## Memo for 2017spring2(Seaster)

- ICB, BDC1,2 configuration
  - V01 : D(BDC1-BDC2)= 1000 mm, ICB
  - V02, V03 : D(BDC1-BDC2)= 750 mm, ICB
  - V04 : D(BDC1-BDC2)= 1000 mm, without ICB
    - same configuration as  $^{18}\text{O}$  campaign
- other questions

Setup\_up (Seaster) V01  
minimum change from Arp. run  
27-Mar-2017 TK

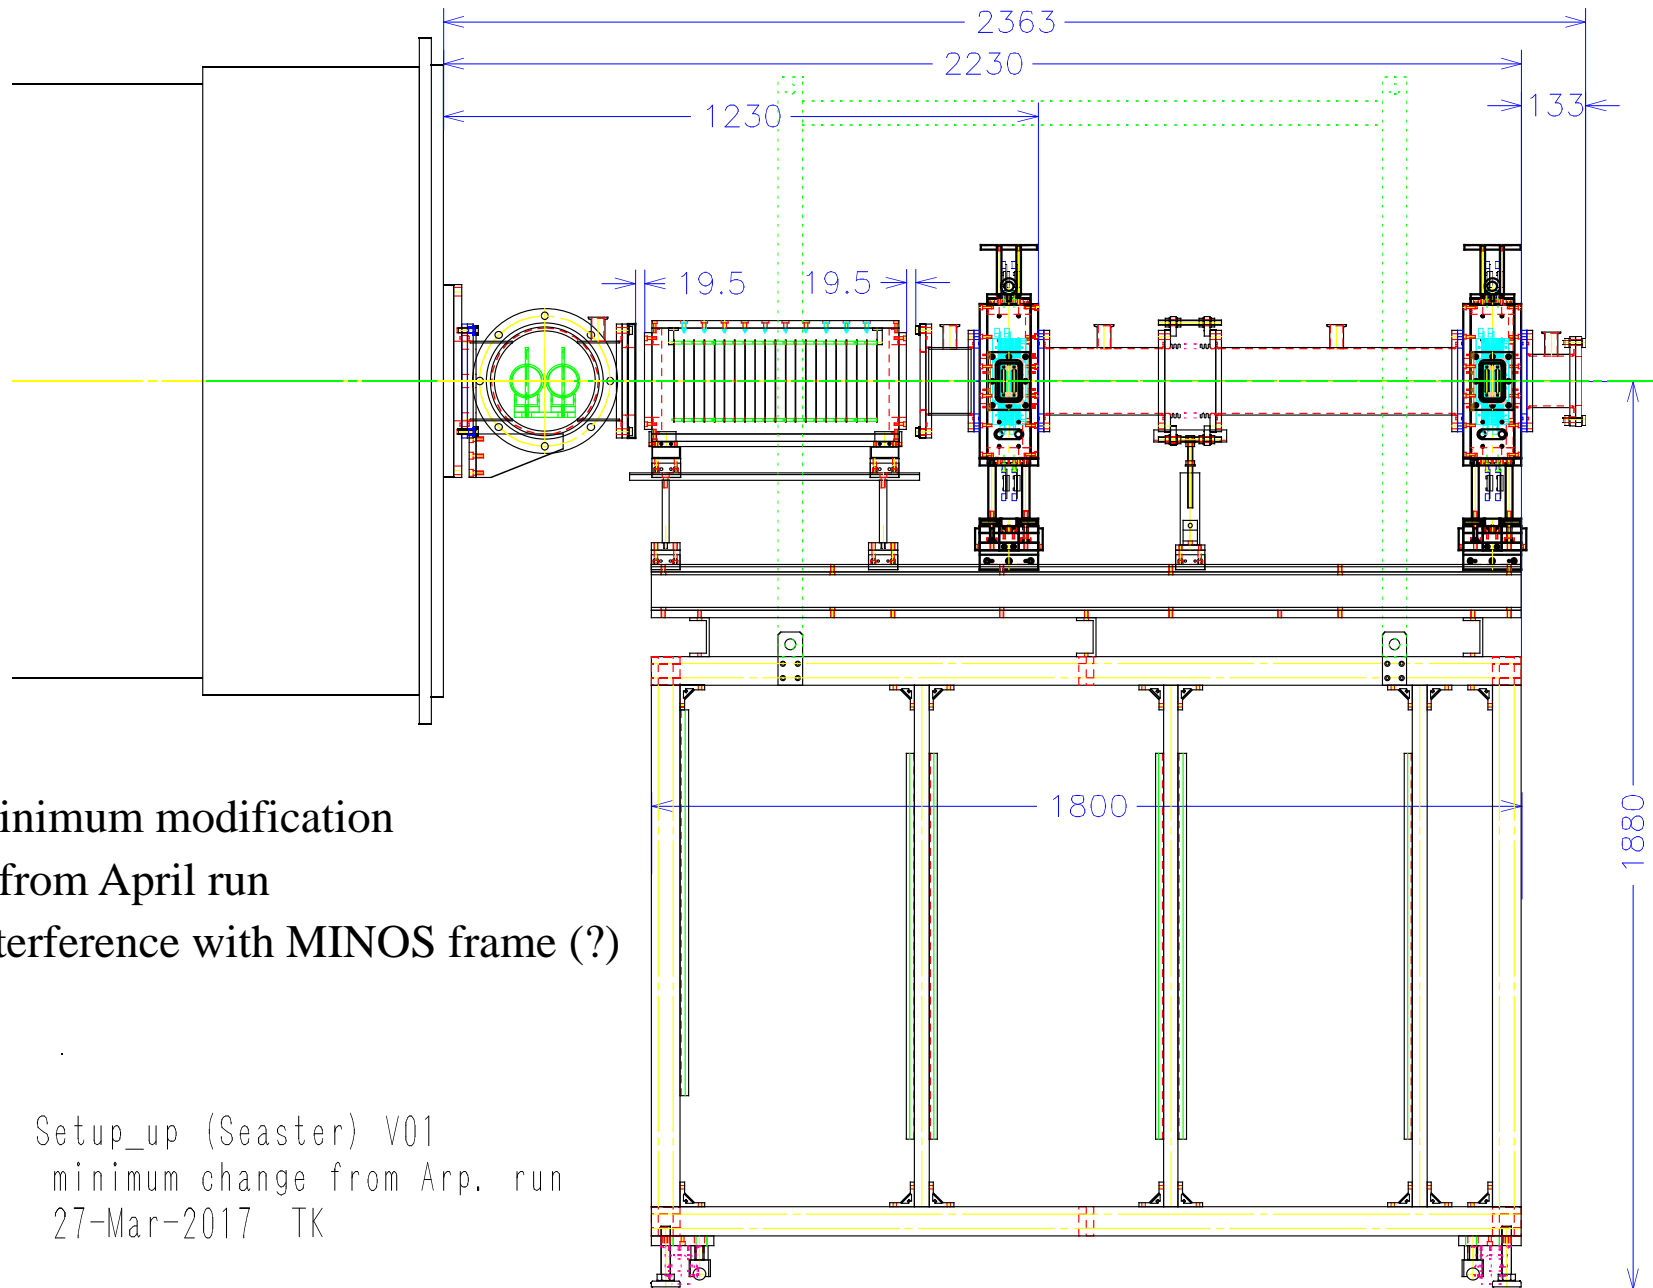
- Minimum modification
  - from April run
- interference with MINOS frame (?)

# Upstream for Seaster V02

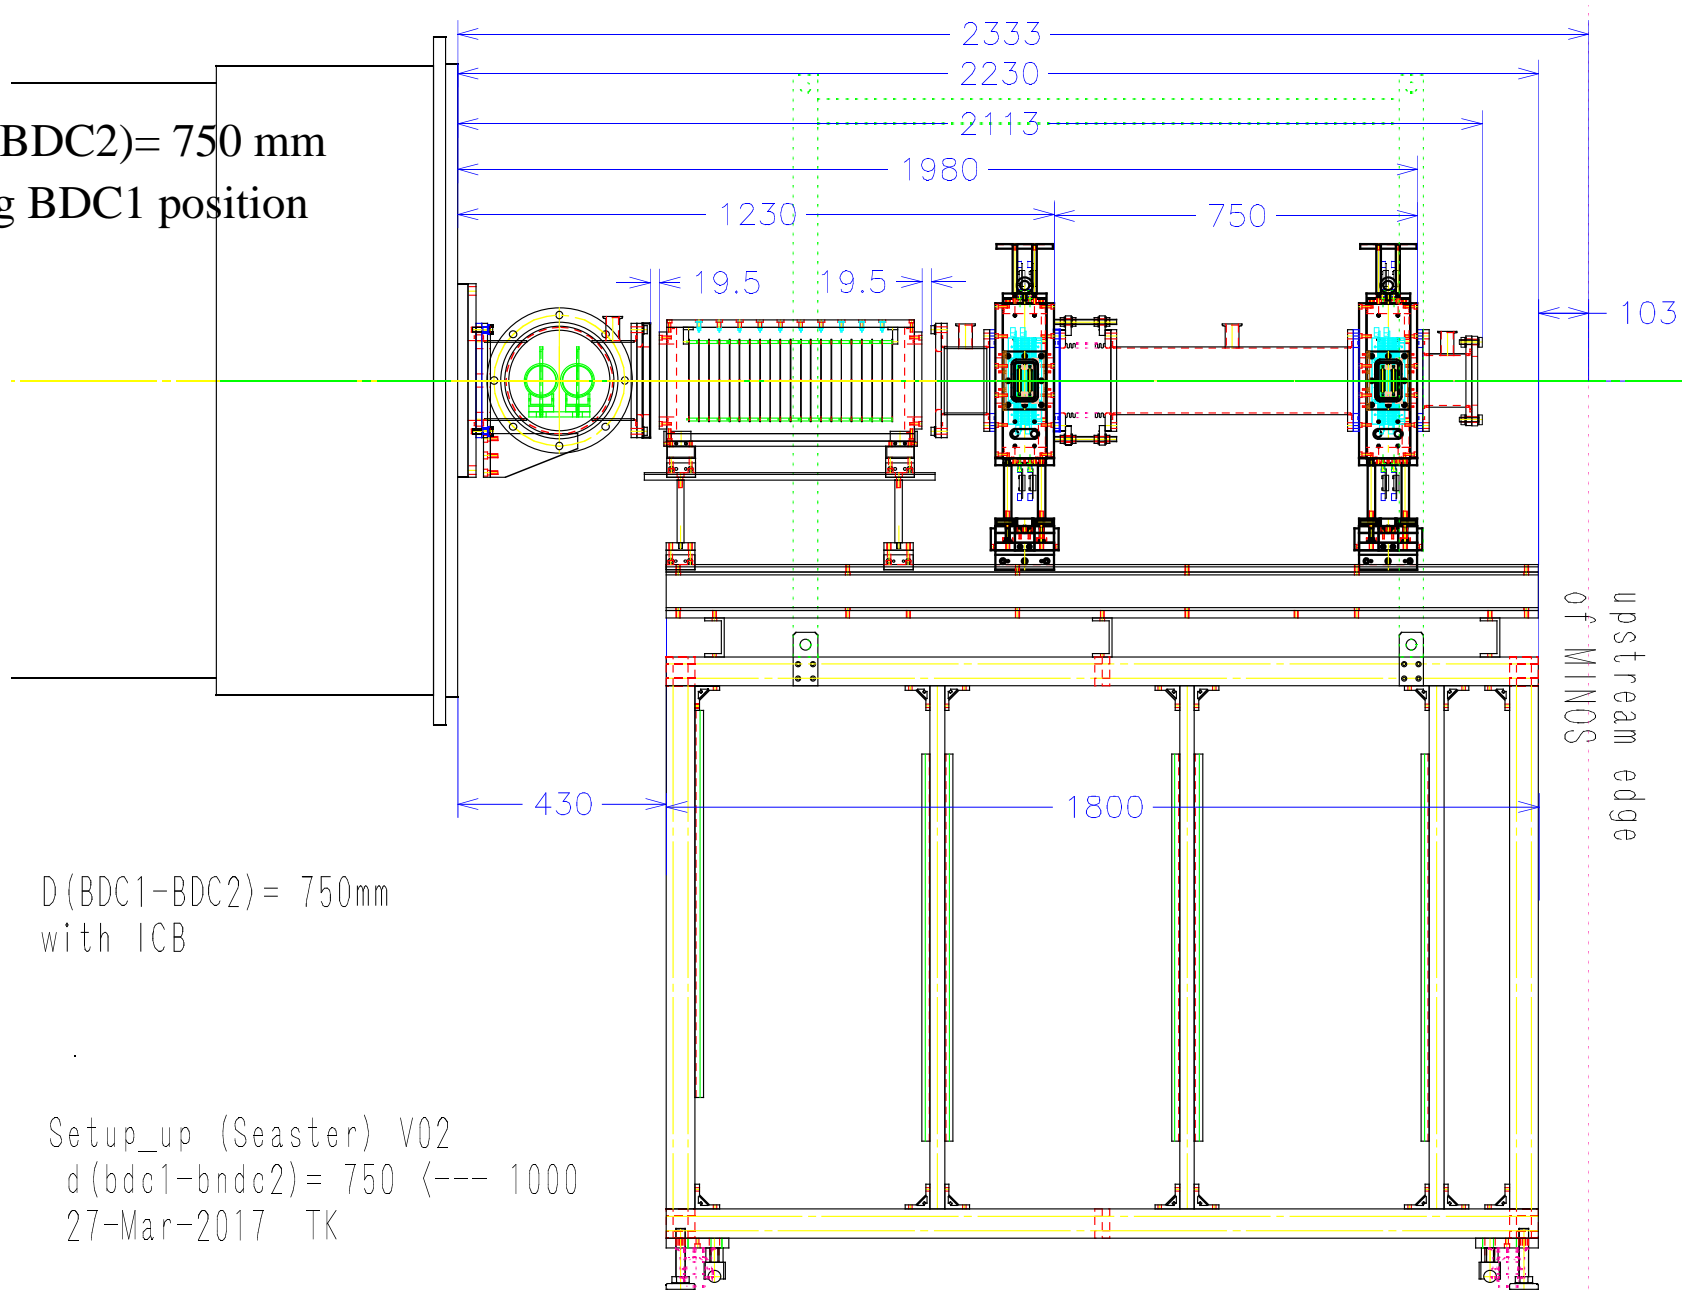
- $D(\text{BDC1-BDC2}) = 750 \text{ mm}$ 
  - keeping BDC1 position
- with ICB

Setup\_up (Seaster) V03  
keep BDC2 position  
27-Mar-2017 TK

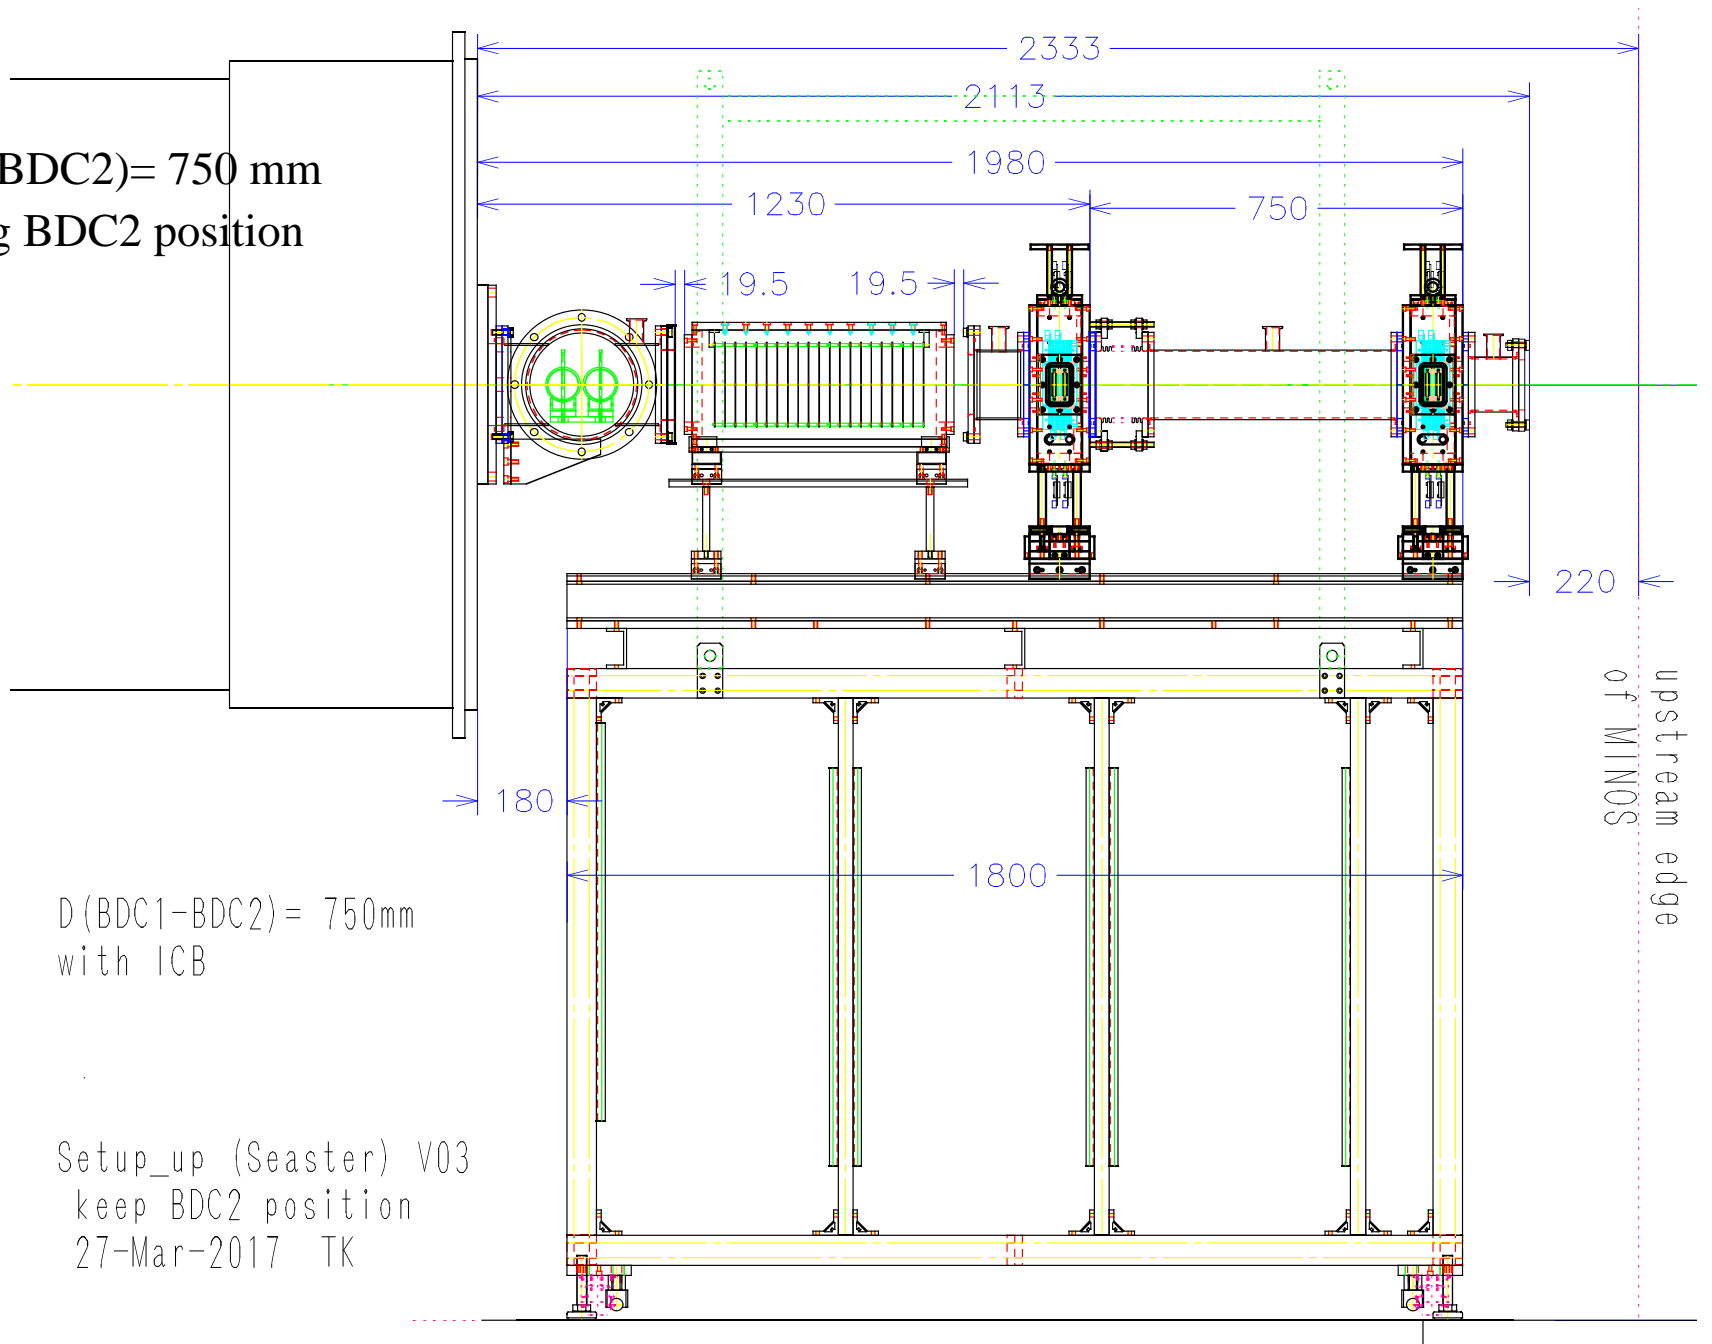
- $D(\text{BDC1-BDC2}) = 750 \text{ mm}$ 
  - keeping BDC2 position
- with ICB

- SBT, ICB, BDC1,2 configuration ?
  - p2-p5 :
  - V3 (page5) OK?
- can gate valve be removed ?
  - which gate valve? between target & FDC1?
  - I think it is OK to remove GV between entrance window (after the target) & FDC1
    - if vacuum can be kept all the time
- SAMURAI magnet ?
  - no need to be on all the time.
- detector tuning (BDC,1,2, FDC1,2)
  - HV curve for K beam (or abundant species), and use the common HV from K to V
- HODF24
  - use the same HV setting for Ca beams in April?
  - sweep probably not necessary

# Upstream for Seaster V04 (same as $^{18}\text{O}$ campaign)

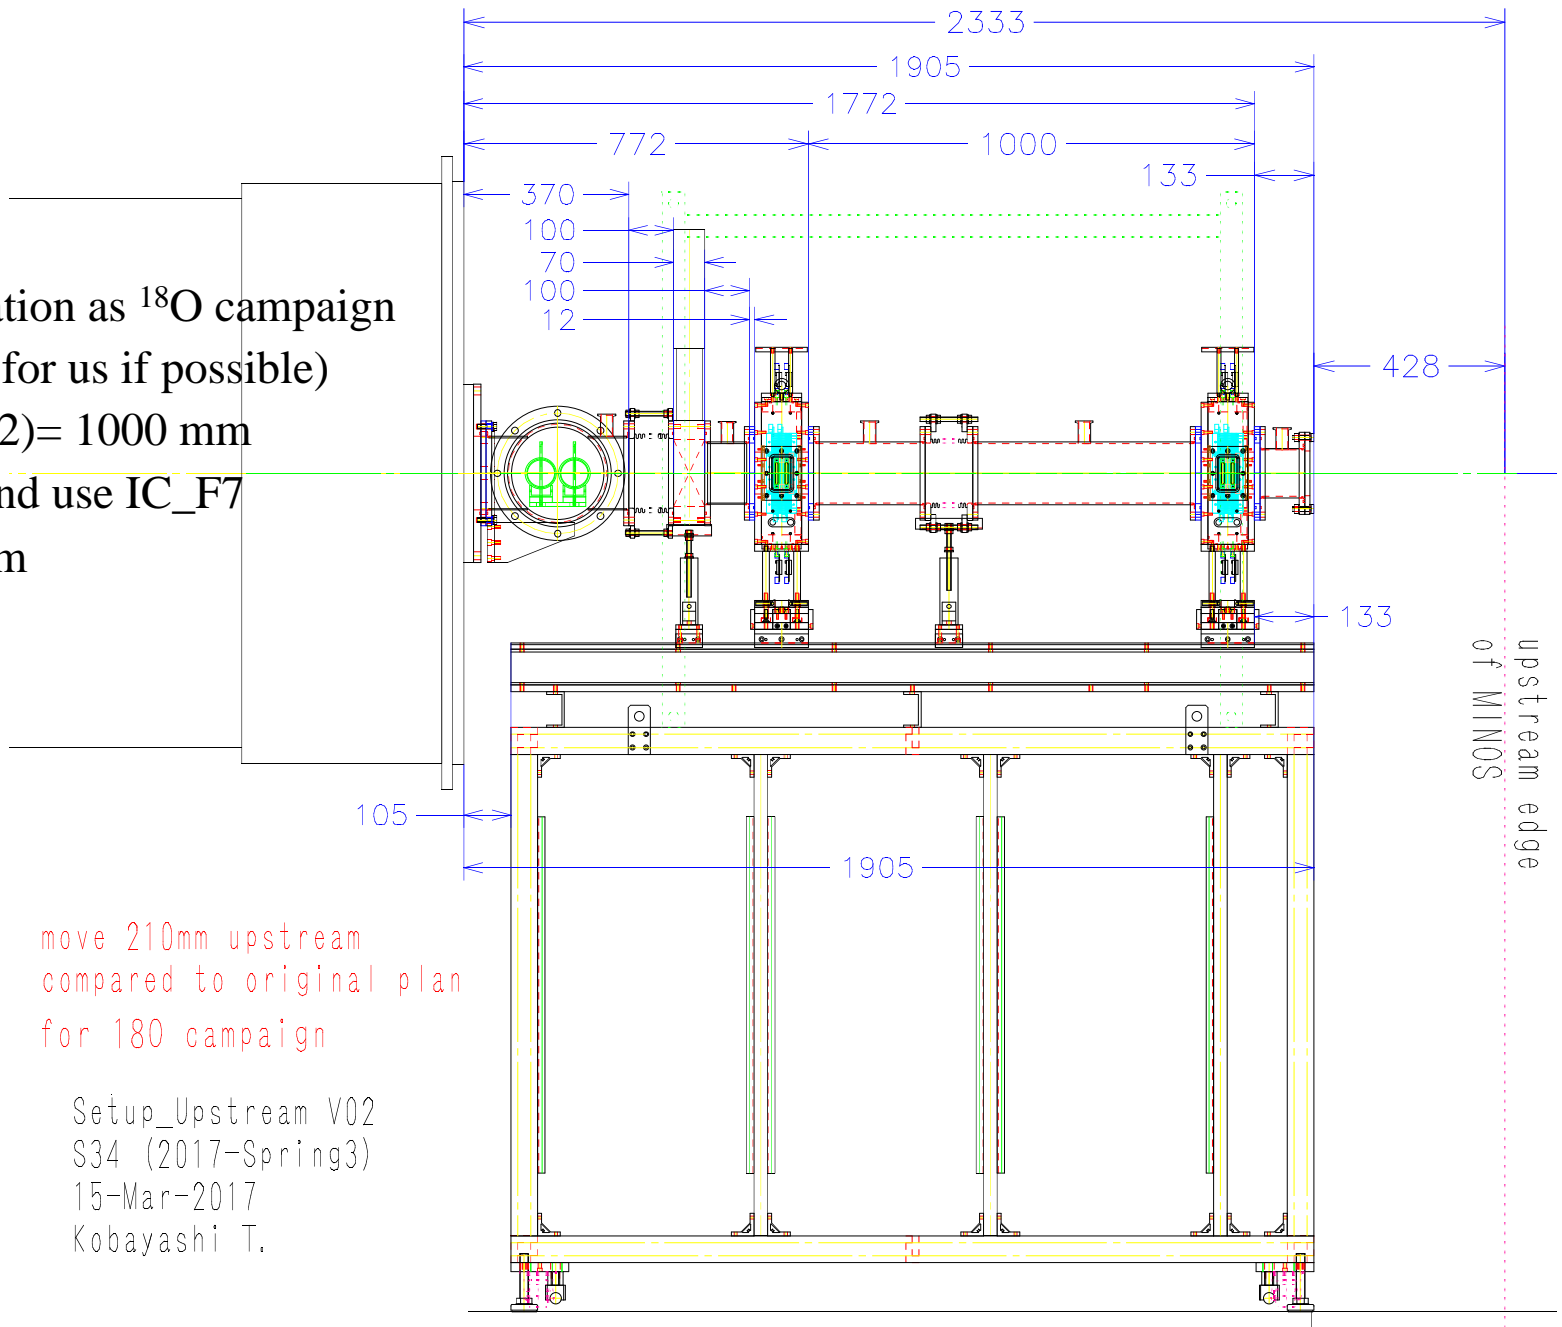
- same configuration as  $^{18}\text{O}$  campaign
  - (convenient for us if possible)
- $D(\text{BDC1-BDC2}) = 1000 \text{ mm}$
- without ICB, and use IC\_F7
- $t(\text{SBT}) = 0.2 \text{ mm}$

move 210mm upstream  
 compared to original plan  
 for 180 campaign
